# Transmittal Memo

Re: CHILD Development Complex - Opelousas - (Electrical)

Re: Child Development Complex - Opel. La. (Electrical)

ELECTRICAL SERVICE WIRING DIAGRAM

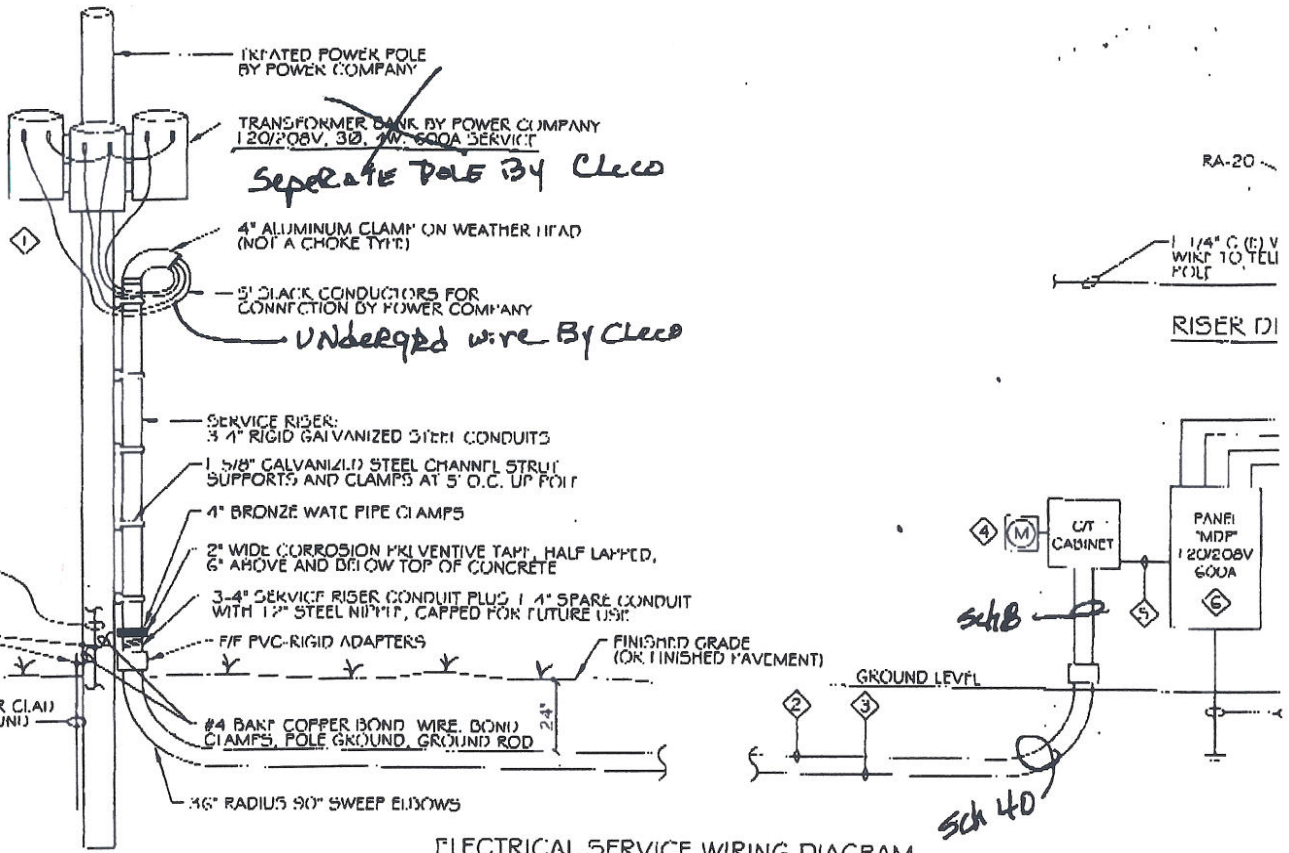
Remarks: We HAVE met w/ Checo Rep. - Needs 2-4# sch 40 MC AND one spare to new pole location as shown on NOT PLAN OK.

We HAVE added ALL Disconnects NOT shown (MUS-EWH-CD#1-Submittal) Provide disconnect for equipment that does not have internal disc. EXTREME ENTRANCE FIXTURES TO BE 70 WATT M.H. SIM FIXTURES (None specified) OK.

Do we need A.F.A. system? No - called out on coversheet.

We are having the pole lights designed by a lighting co. OK

INTERIOR WIRING IN W/C OK, #12 AWG minimum.

*We would like to get some basic submittals on equipment / fixtures. Thanks, RLB*

*By Cleco*
